Fern Bay Seaside Village Project Application

Further Response to Submission Report

Date:	7 April, 2010
Partner:	 Paul Douglass

Aspen Group

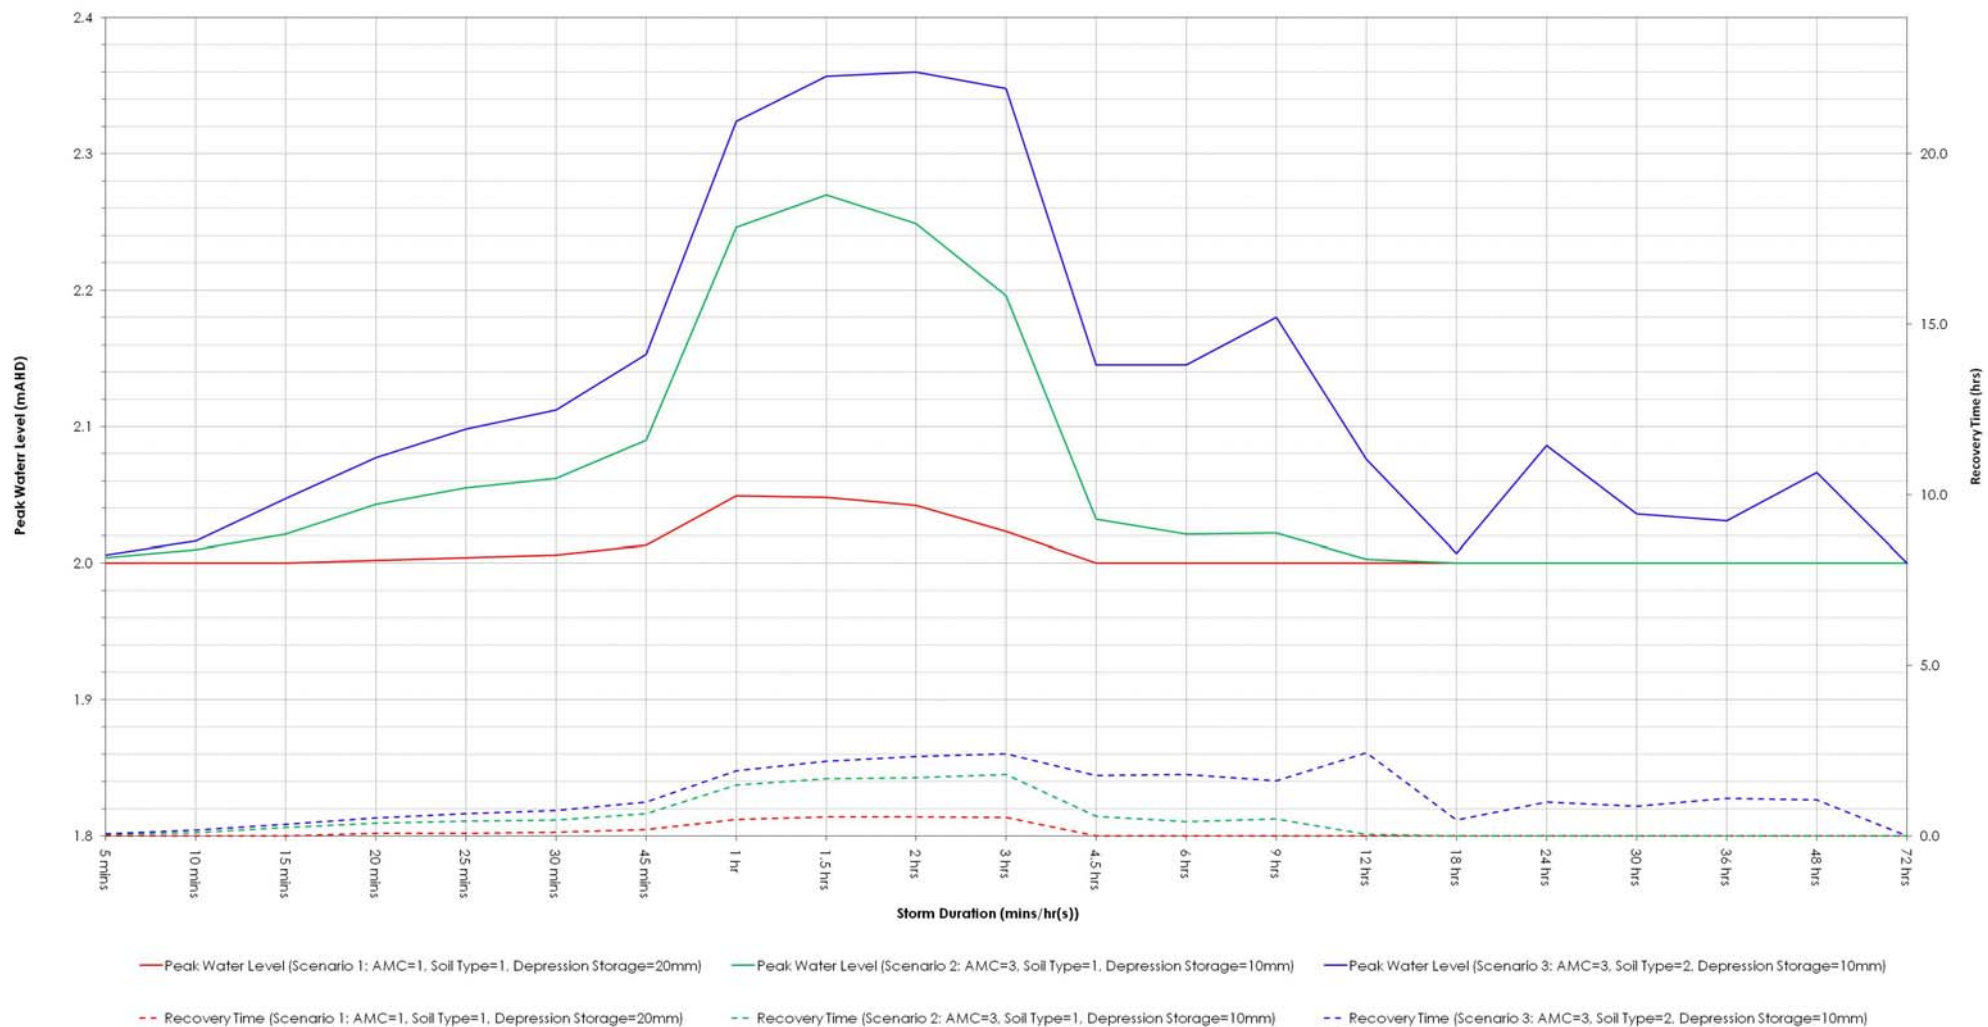
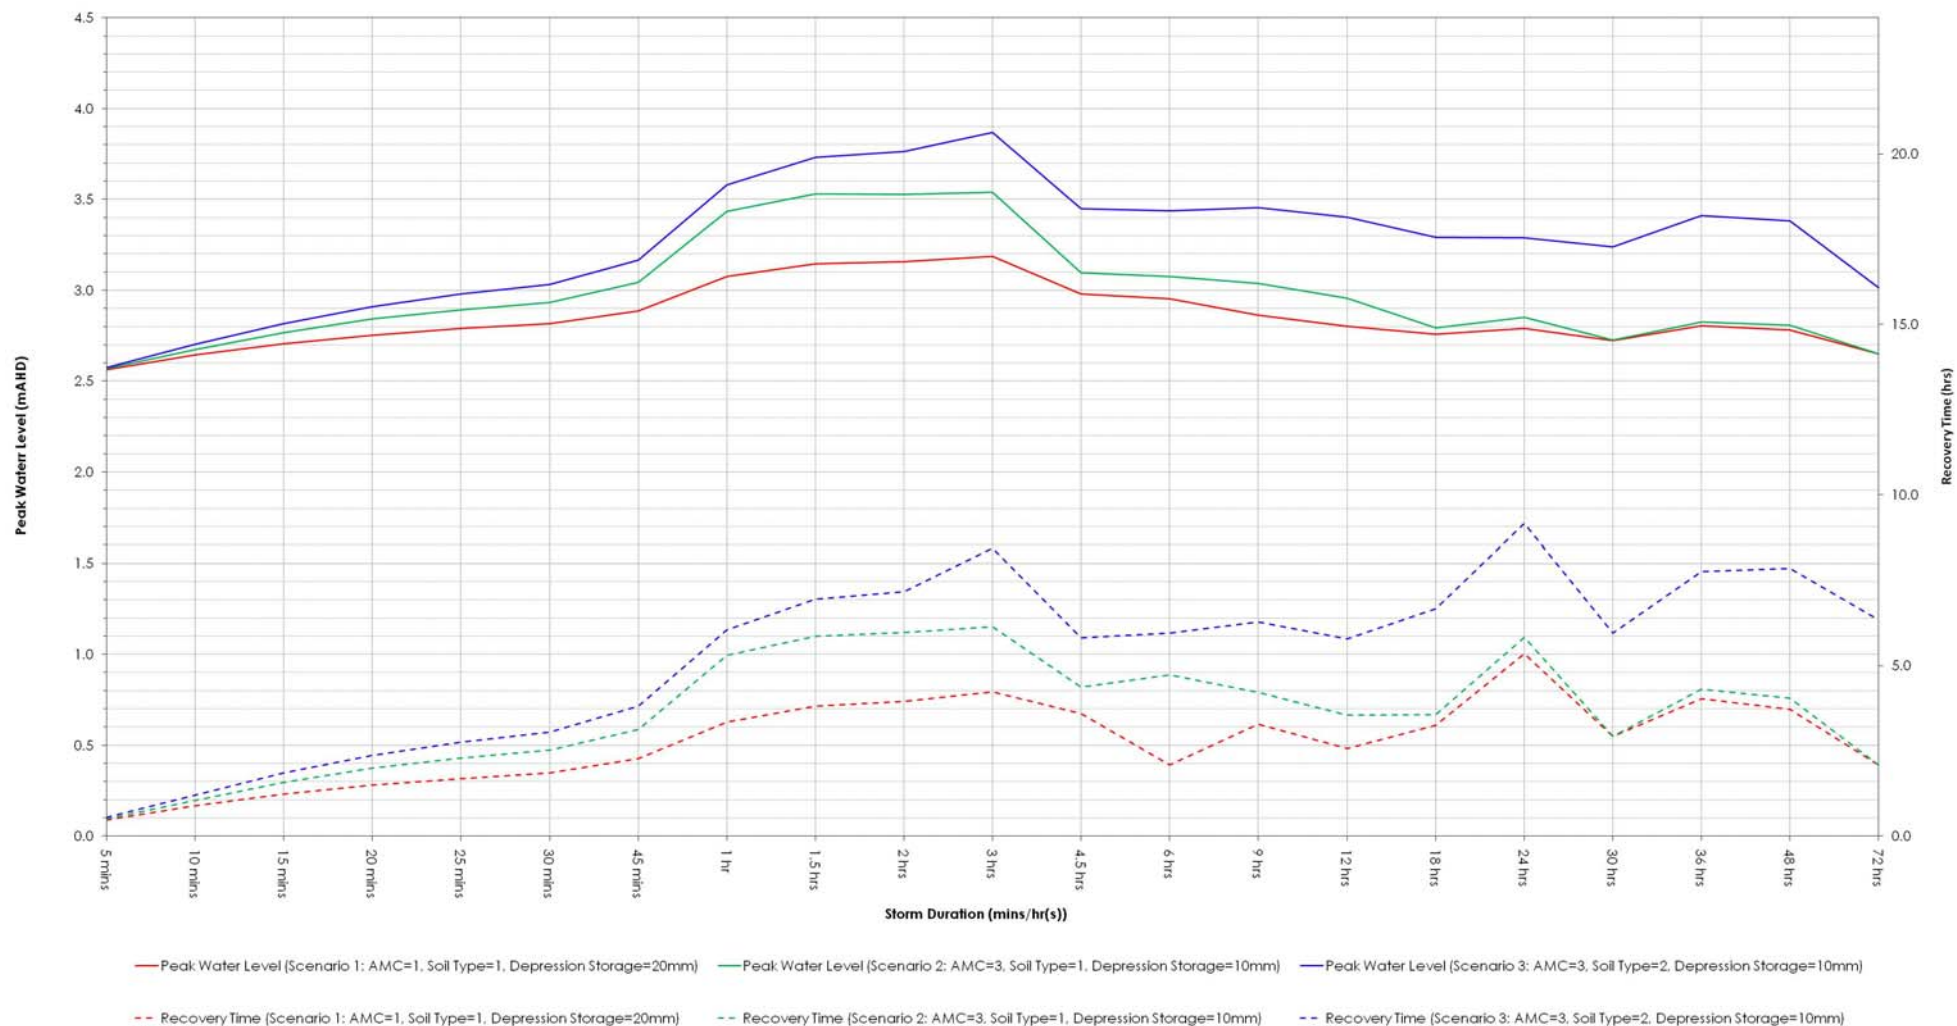
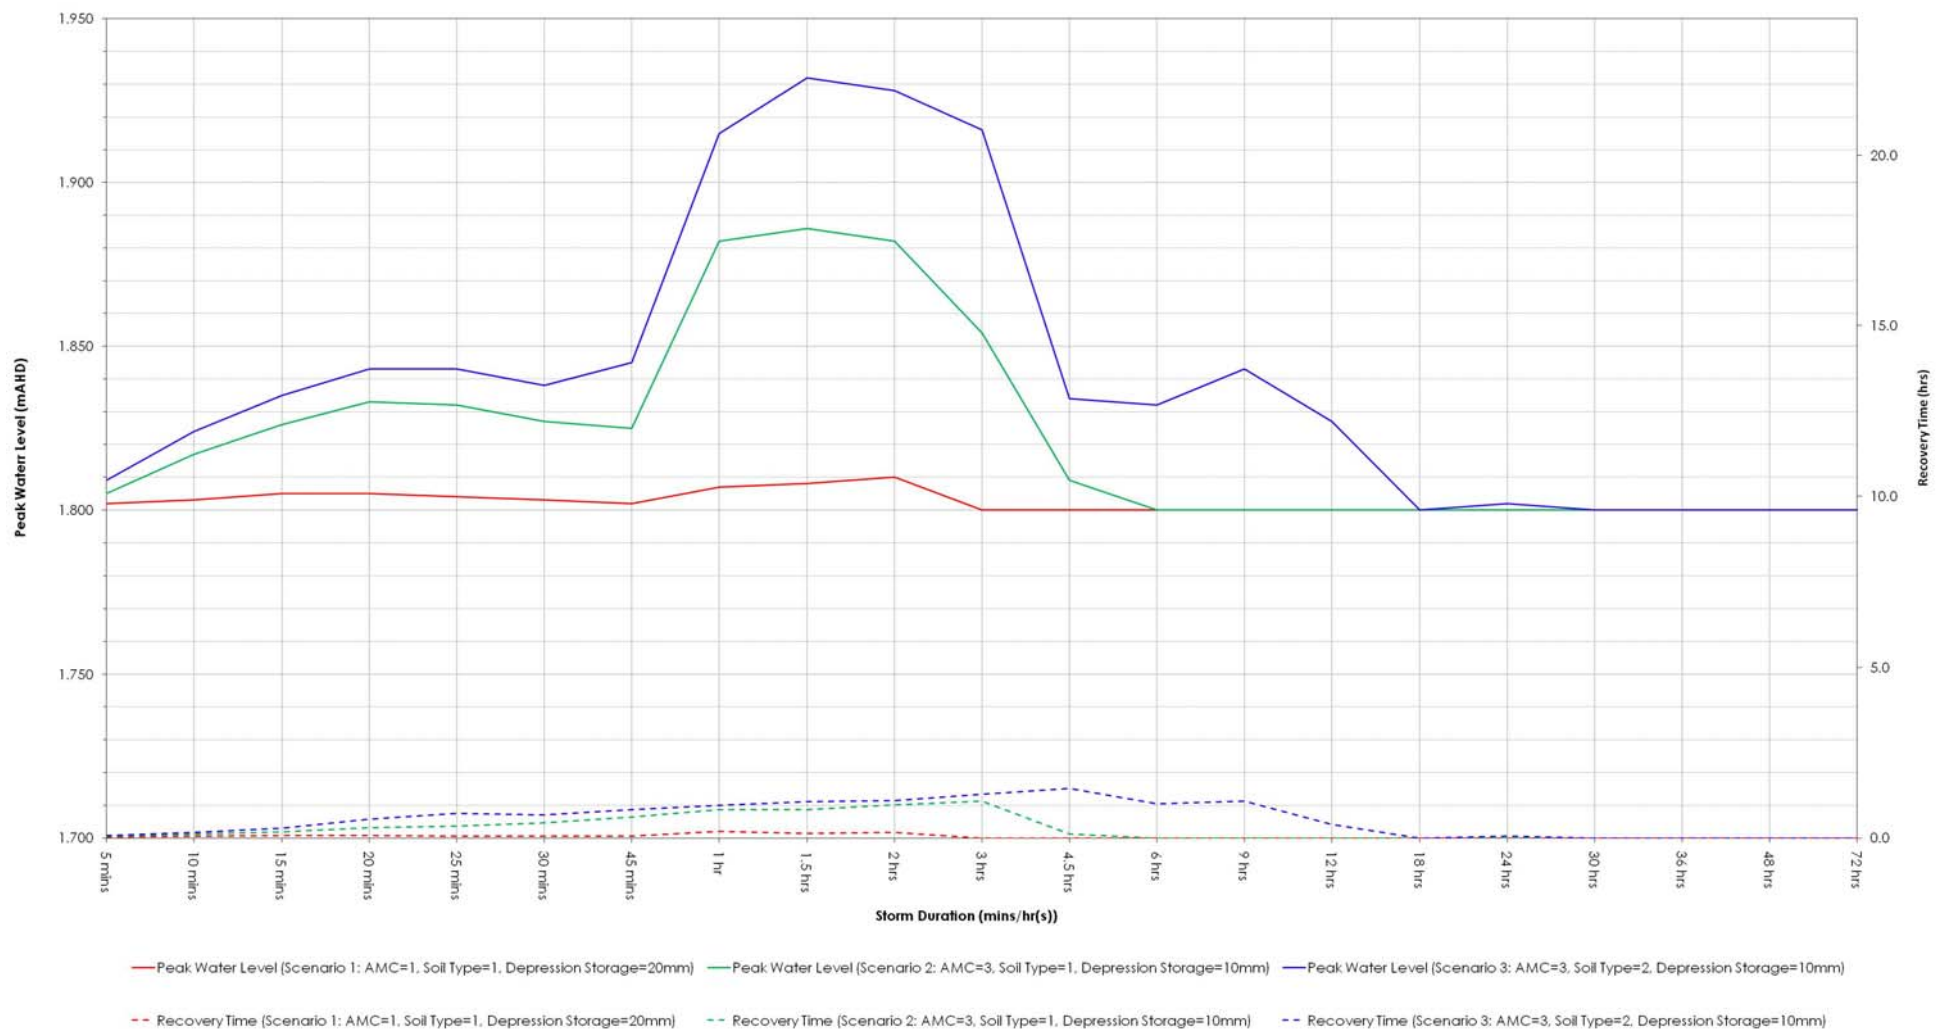
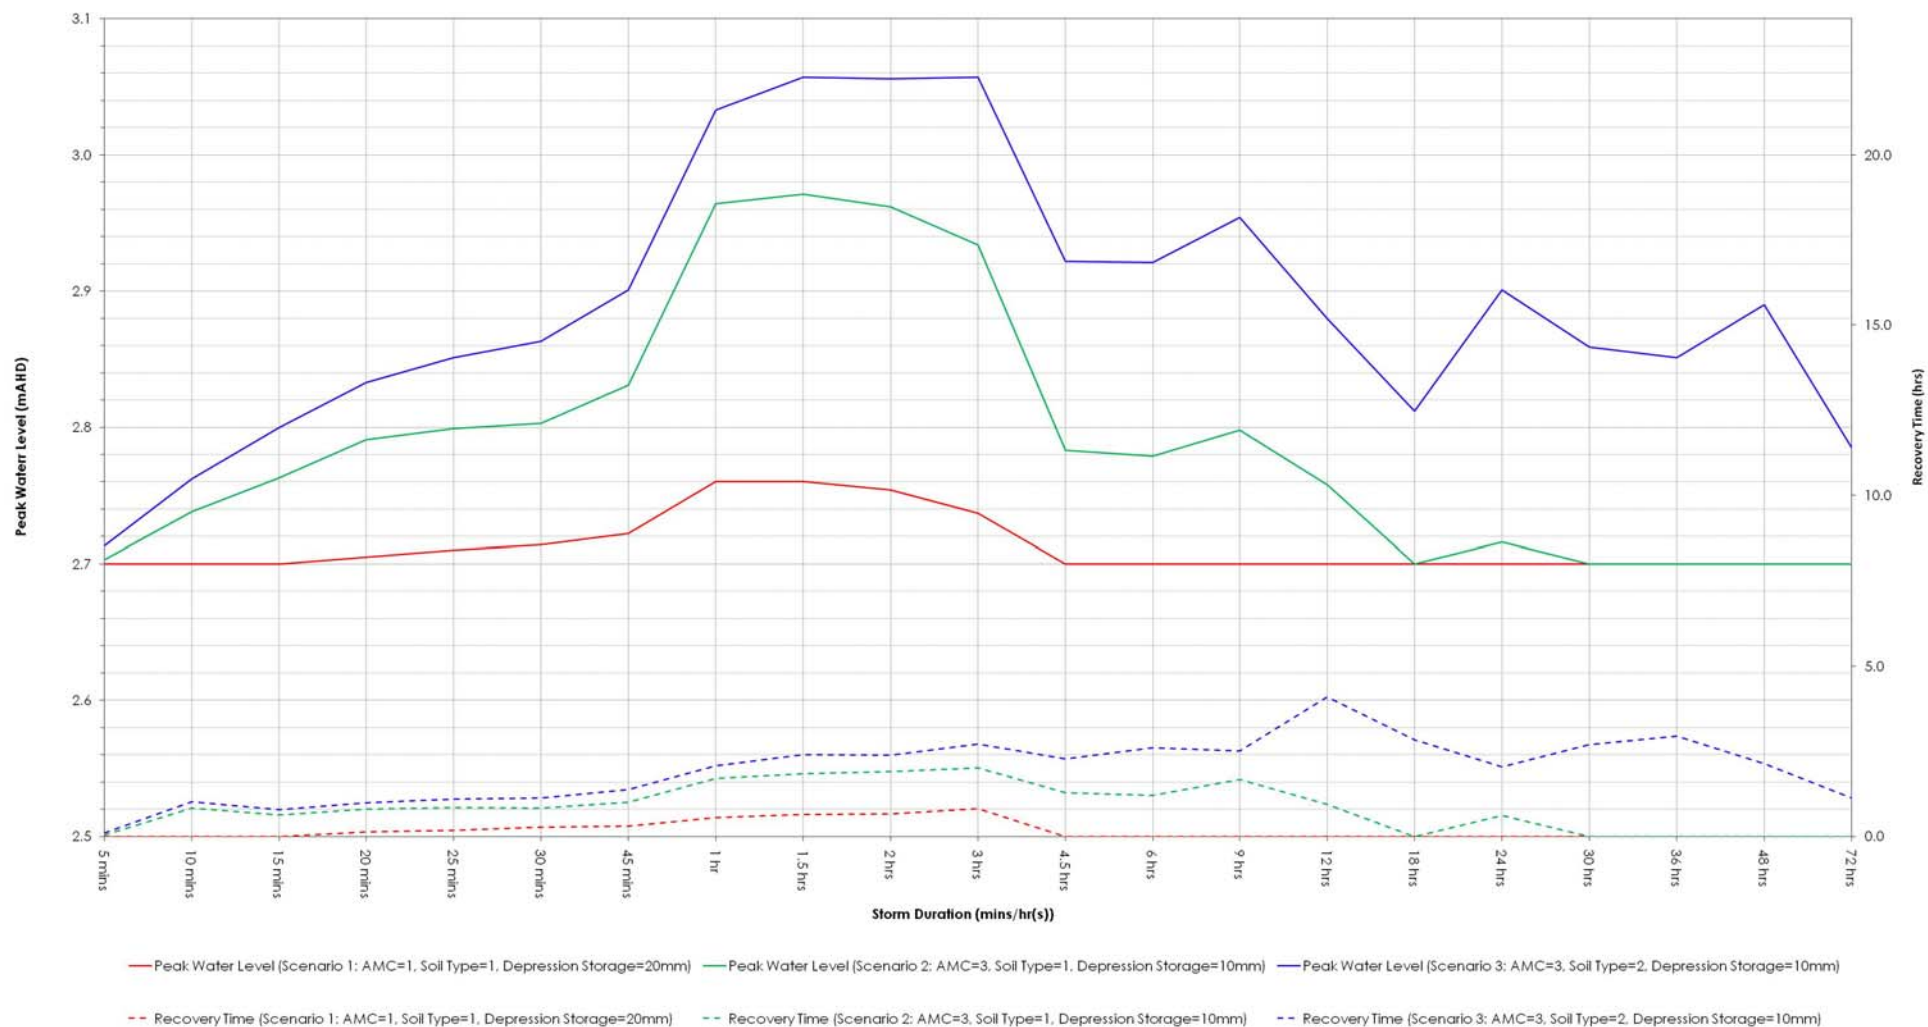
Clarify the likely recovery rate of basin water levels following a 100 year ARI storm event. If basin recovery times are more than a few days, then a sensitivity analysis of the 'embedded storm approach' should be undertaken.

Results of the peak water level analysis are provided in Figure 3 through to Figure 8 and summarised in Table 9.

Results of the basin recovery time analysis are also provided in Figure 3 through to Figure 8 and summarised in Table 10.
